New Discovery Mines Ltd.
1909 108 West Cordova St.
Vancouver, B.C.
V6B 0G5

Structure Description and Construction Plan

Waste Rock, Ore Storage and Trails

For MV2020L2-0002

Site Plan As Placed May 24, 2021

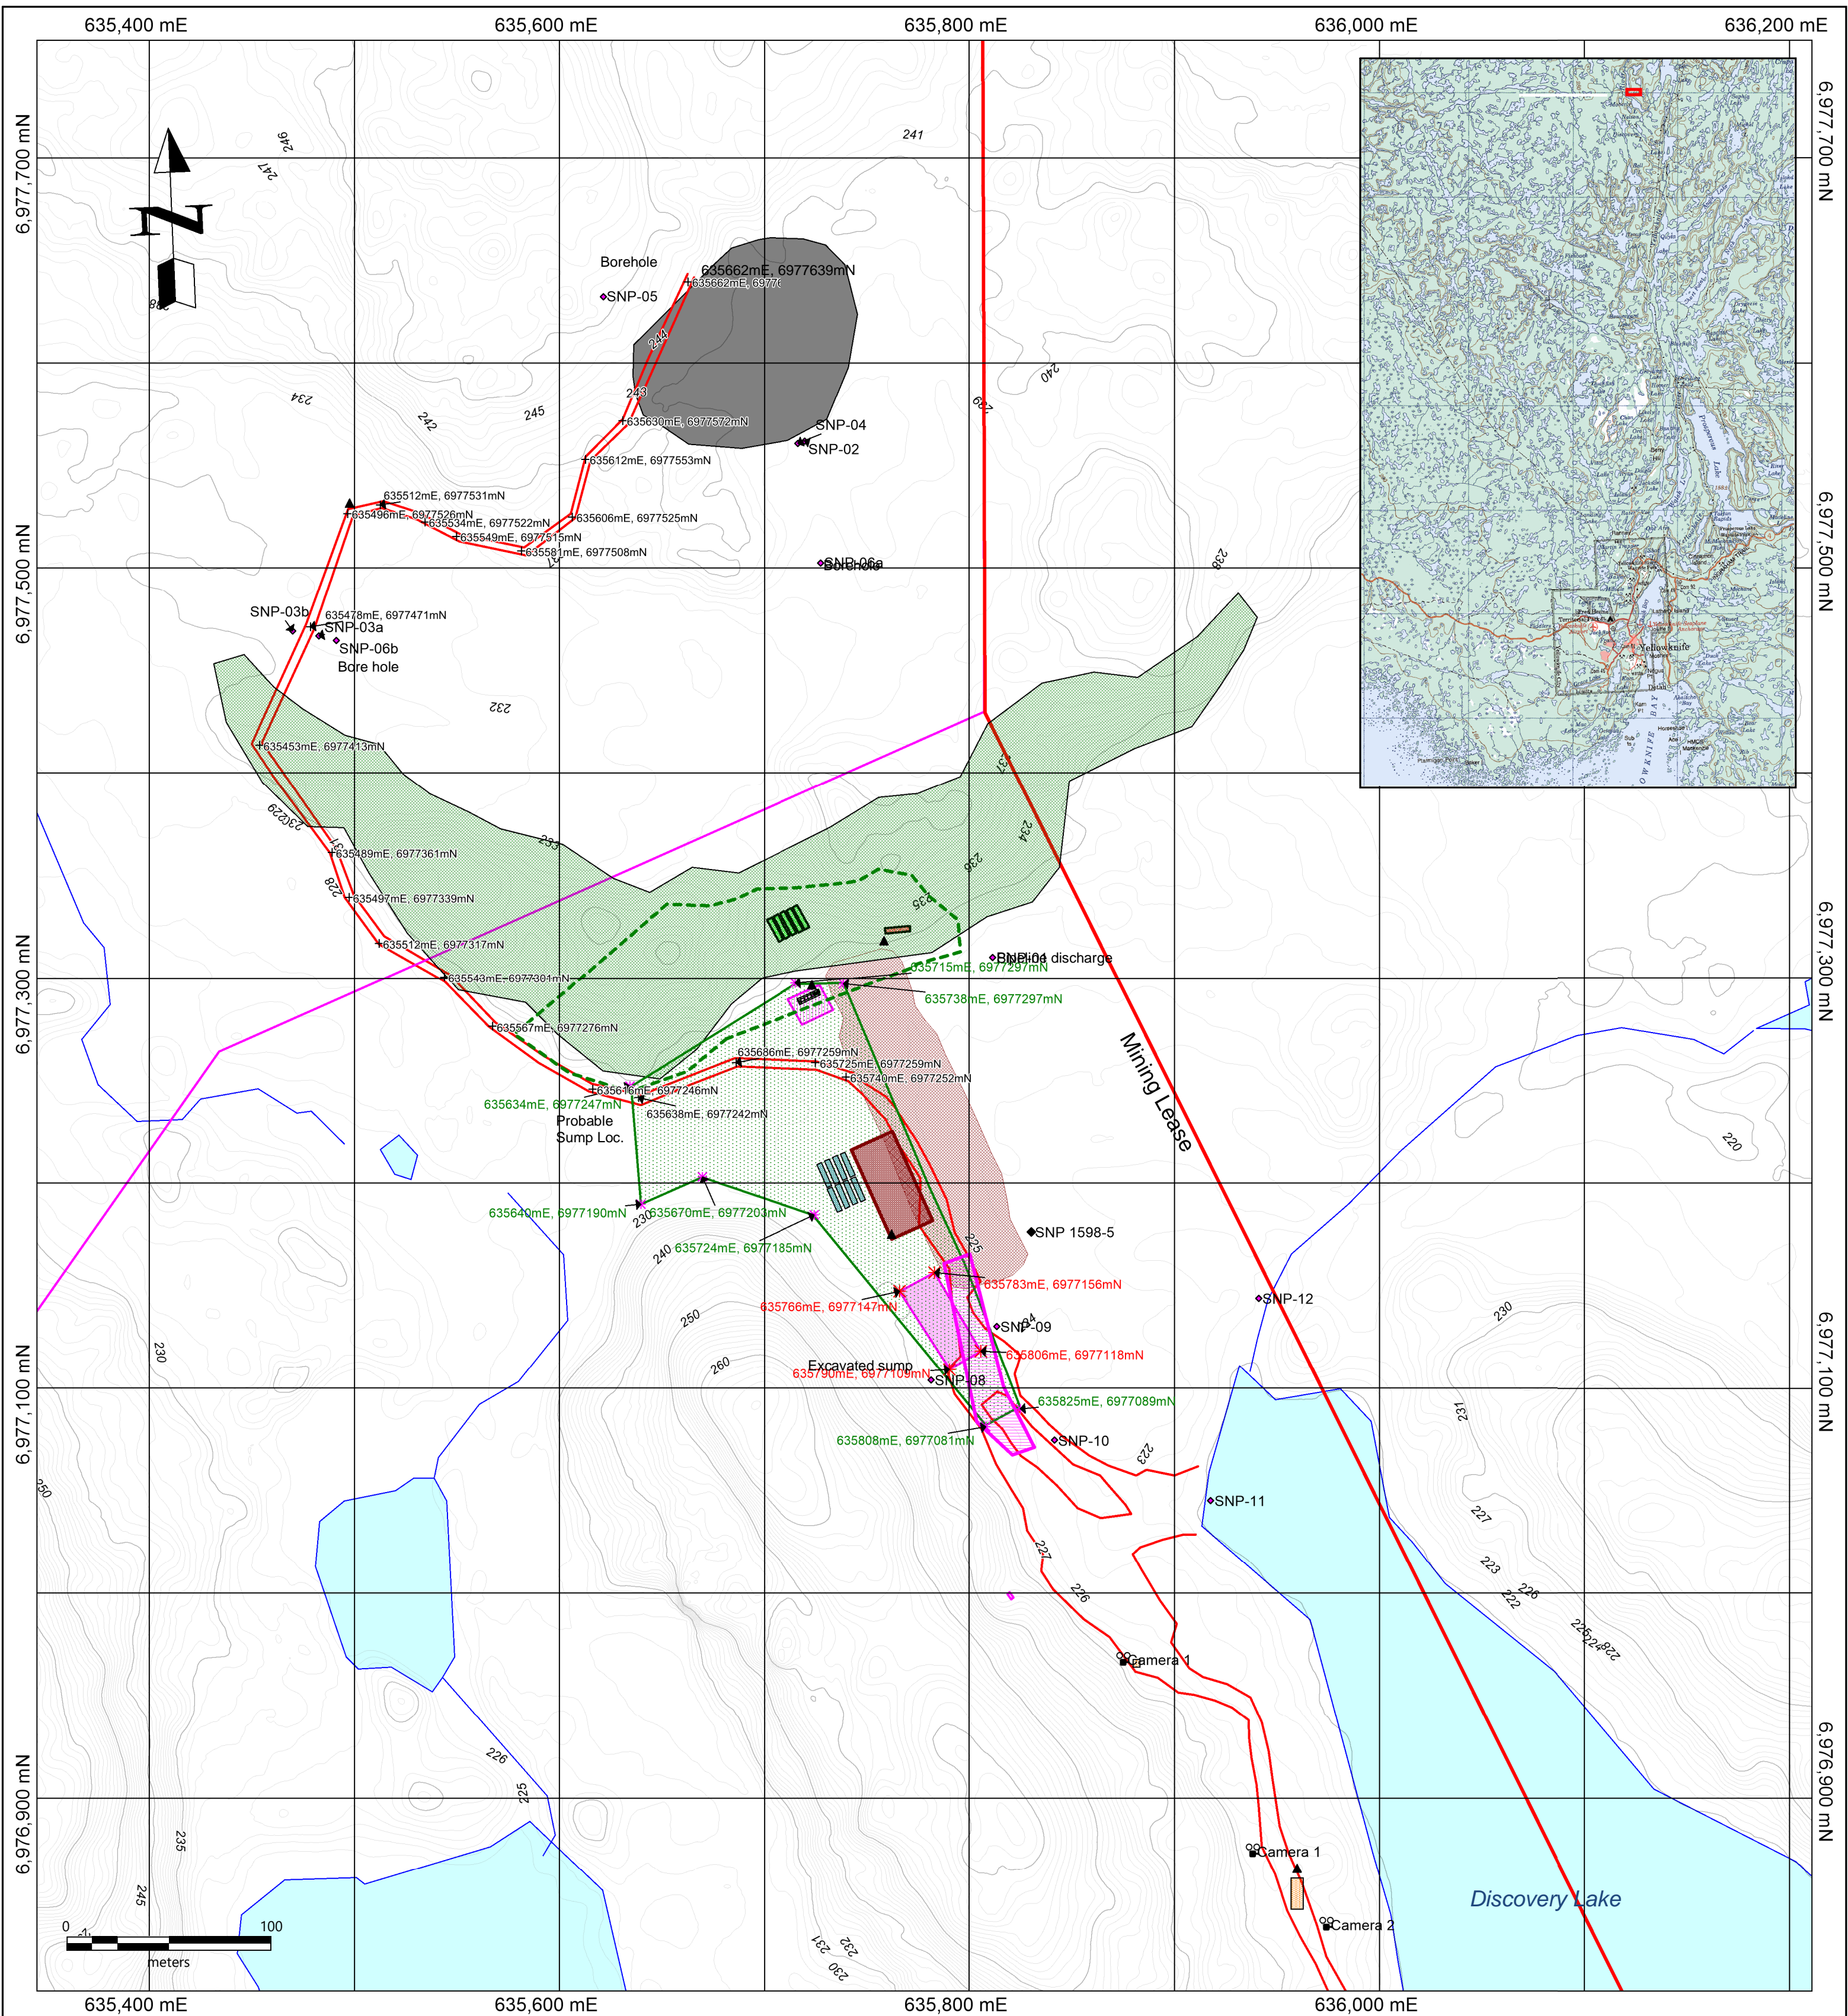
<p>clear from the Site Map (Appendices) whether drainage from the waste rock and ore pile drain into the excavated sump (shown in the map) where it is treated before discharge, or whether the seepage bypasses the excavated sump and is then monitored at the SNP-09 & SNP-10 location.</p> <p>References: -Structure Description and Construction Plan -Waste Rock, Ore Storage and Trails- Section: 2.0: Facility Description; Background of area; Specification; Potential Effects on the Receiving Environment- Appendices: Site Map</p>		
1	Mr. Patrick Clancy	ENR Cover Letter to the MVLWB	N?A	
2	Mr. Patrick Clancy	ENR Letter to the Proponent	For the Proponent

3	Mr. Patrick Clancy	<p>While there is no reference within the Plan, ENR notes from the ORS review item that the plan is required under Part E, Condition 7 of Water Licence MV2020L2-0002. Part E, Condition 7 refers to Schedule 3, which outlines the information required within the plan. There is no reference to these requirements within the plan or linkages to locations within the document that this information can be found.</p>	<p>1) ENR recommends that the plan be updated to include a concordance table which directs reviewers to specific locations in the plan which correlate to the information requirements outlined in the Water Licence.</p>	<p>A concordance table is added.</p>
4	Mr. Patrick Clancy	<p>The site plan provided is somewhat unclear. Based on the map and legend included, it is difficult to determine the location of the waste rock storage, the esker, etc.</p>	<p>1) ENR recommends that the site plan be revised to outline the locations of the various mine components more clearly.</p>
